**INDIANA
MICHIGAN
POWER®**

SUBJECT: Donald C. Cook Nuclear Plant Units 1 and 2
Docket Nos. 50-315 and 50-316
Response to Request for Additional Information Regarding Technical Specification
Change to Reactor Trip System Instrumentation and Engineered Safety Feature
Actuation System Instrumentation

Enclosure 2 to AEP:NRC:7331-01

Figure 1

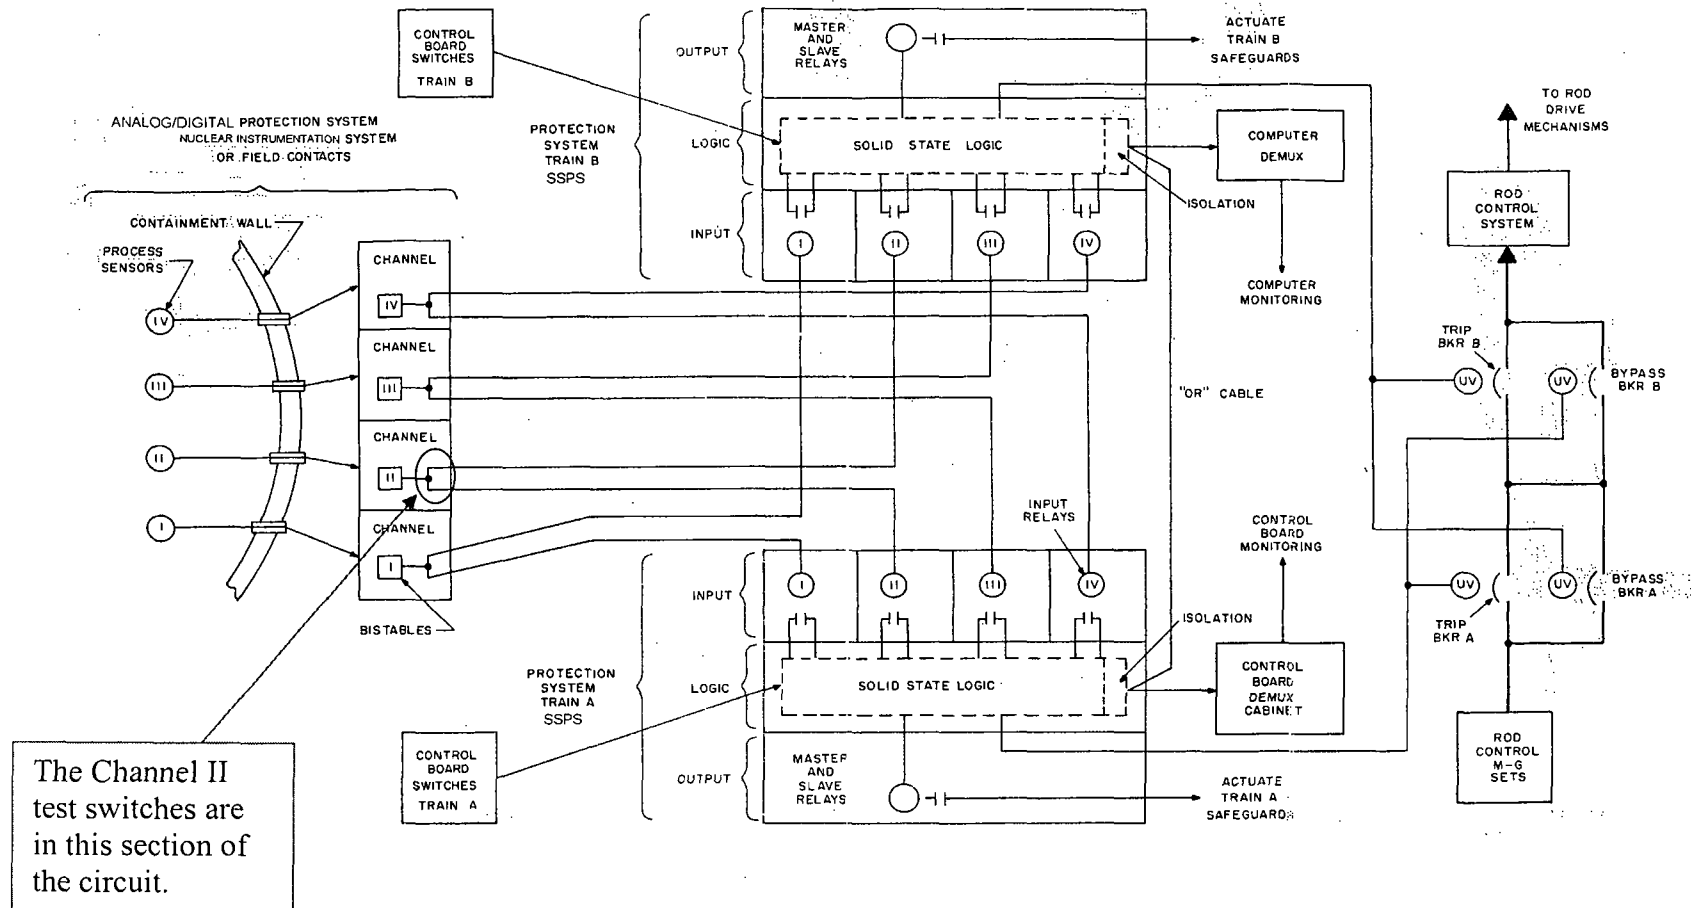
During a telephone conference held between I&M and Nuclear Regulatory Commission (NRC) staff on June 20, 2007, I&M agreed to provide a schematic of the Protection System and the test circuitry that has been modified. Figure 1 identifies a schematic of the Protection System with the section representing the test switch annotated. This area is represented in more detail by Figure 2, as the test circuitry looked before the modification, and Figure 3, after installation of the modification. Two reactor coolant system (RCS) loop flow reactor trip functions in Channel II are represented in Figures 2 and 3. Since, in most cases, the RTS and ESFAS channels are de-energized to trip, if one of the switches represented in Figure 2 were put into test, it would send a trip signal to both Train A and Train B of the solid state protection system (SSPS) equipment for that channel function.

Before Installation of Bypass Test CapabilityFigure 2

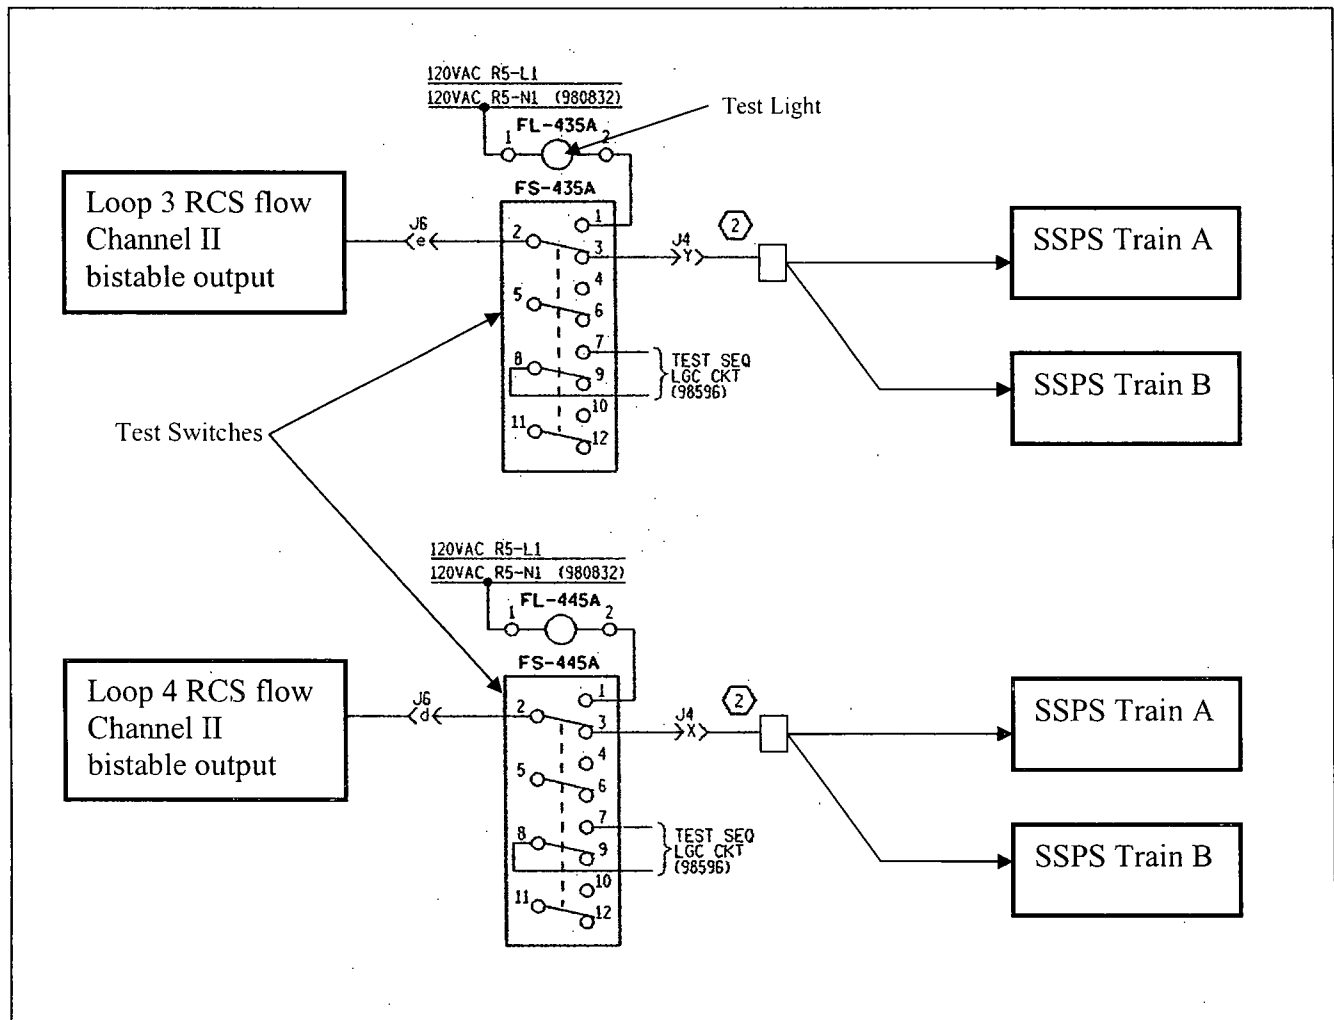
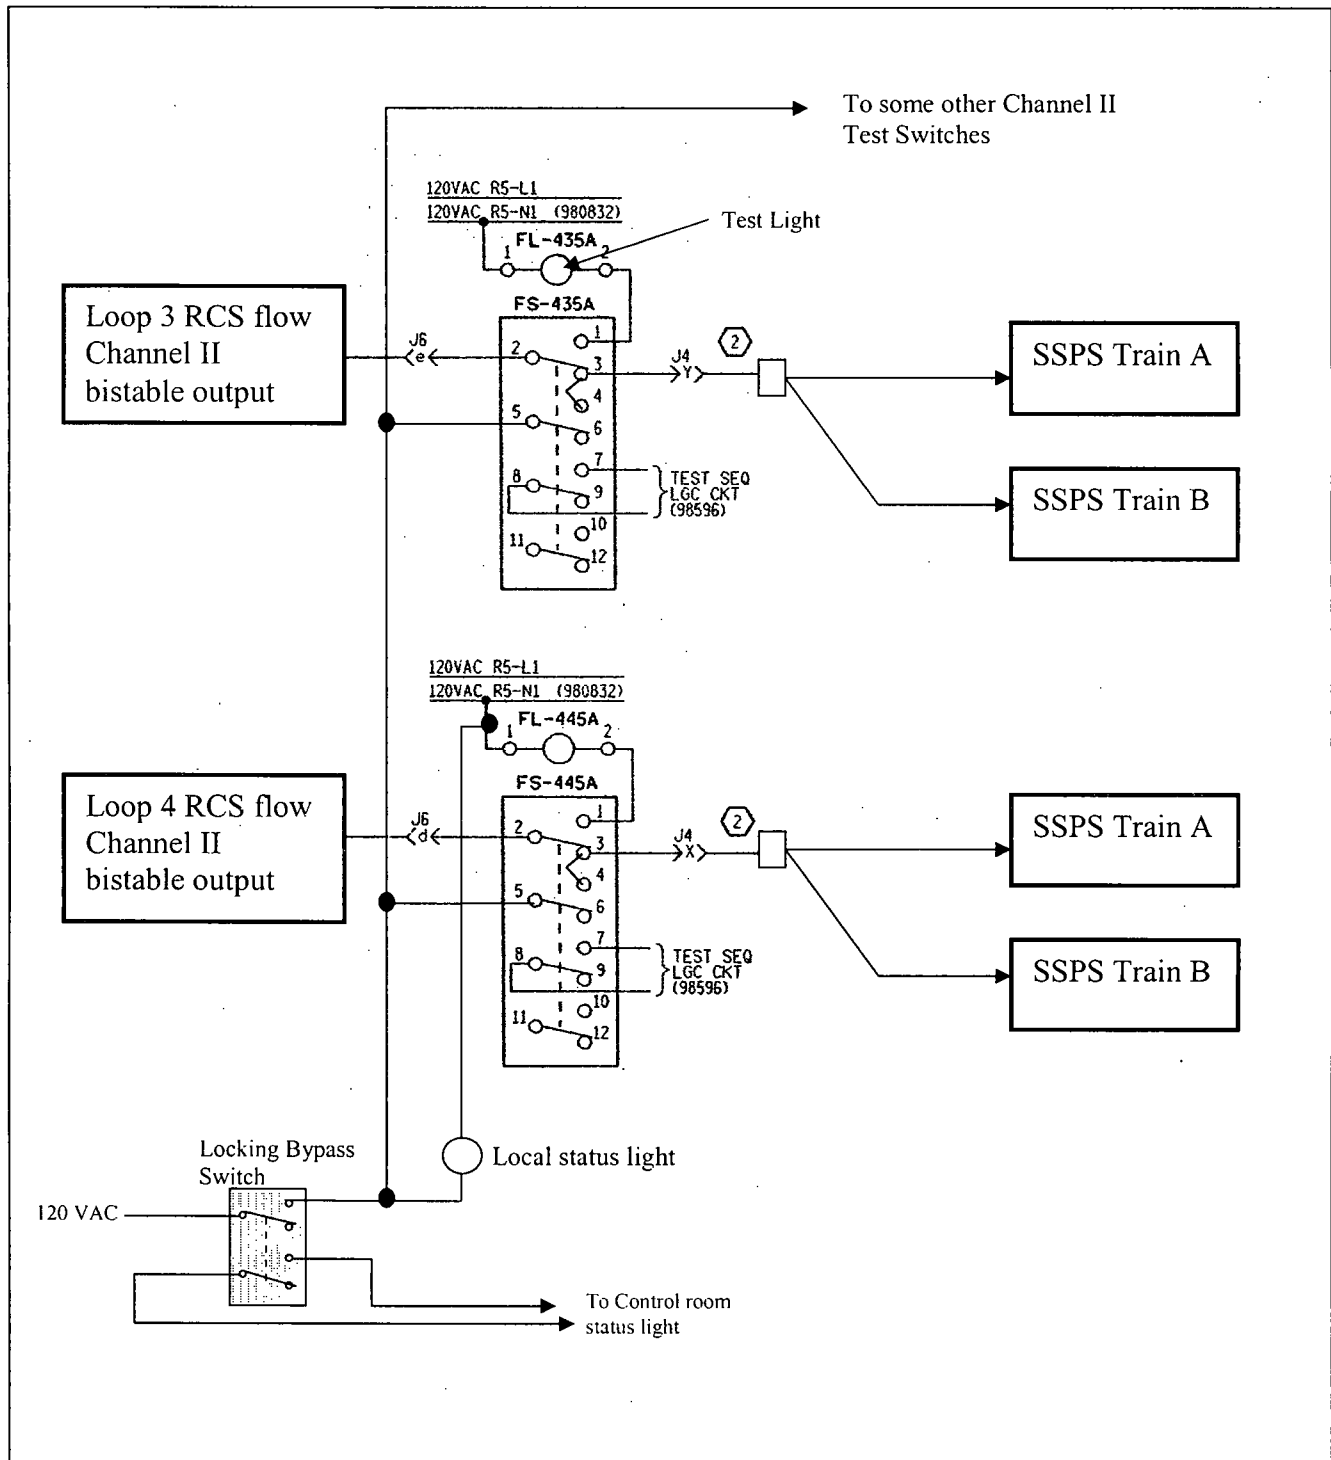
The modification is designed to require two independent manual switch actuations to place a channel in bypass. There is no automatic actuation associated with this bypass circuit. Figures 2 and 3 show that the existing test switches have four poles of double throw switch contacts. The first pole of the switch, which is not changed by the modification, is used to disconnect the bistable signal from the SSPS and connect it to a test light for monitoring the bistable operation during testing. The first pole would cause the channel to become de-energized, sending the trip signal to both trains for that channel function. The third and fourth poles of the test switch, which also are not changed by the modification, are used in the test sequence alarm. Figure 3 shows that the second pole of the switch was modified such that, when a test switch is placed into test, one channel function output to the SSPS trains would be connected to the bypass switch. If the Locking Bypass Switch were placed into bypass by use of a key controlled by the Operations Department, an energized signal would be applied to the input of the SSPS trains, thereby continuously providing power to the channel function, indicating a non-tripped condition. The Locking Bypass Switch is connected to status lights to provide indication both locally and in the control room when a channel bypass switch is armed.
